**No. 97-2**

## MerCruiser MCM/MIE Inline Diesel Heat Exchanger End Cover Torque

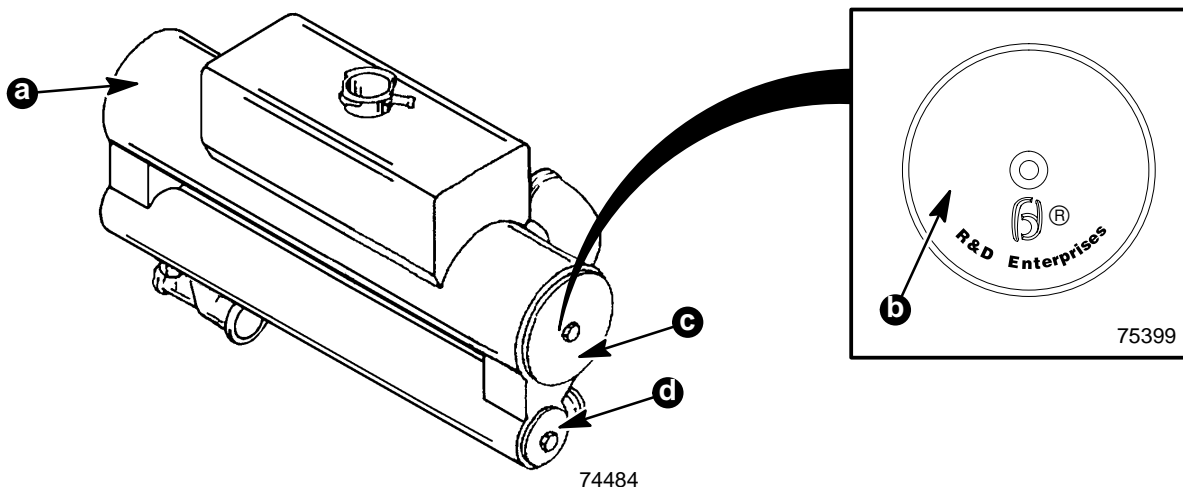
The Heat Exchanger has changed to a **P/N 807261**: on the above model engines. This change includes new cast end covers on the main tank, which can be identified by the "R&D Enterprises ©" cast into the end cover. This cast cover uses a lower torque rating than previously required on the stamped end plates that were used on the heat exchanger main tank, **P/N 806830T**. The torque specification for both heat exchangers are as follows:

**IMPORTANT:** This new heat exchanger P/N 807261 will not backfit on engines below the serial numbers listed above.

DESCRIPTION			TORQUE		
Part Number	Heat Exchanger	Cover/Plate Location	Lb. In.	Lb. Ft.	N-m
807261	New-Style, Cast End Covers	Main Tank (Upper)	120-132		14-15
		Engine Oil Cooler (Lower)	108-120		12-14
806830T	Previous-Style, Stamped End Plates	Main Tank (Upper)		16	22
		Engine Oil Cooler (Lower)	108-120		12-14
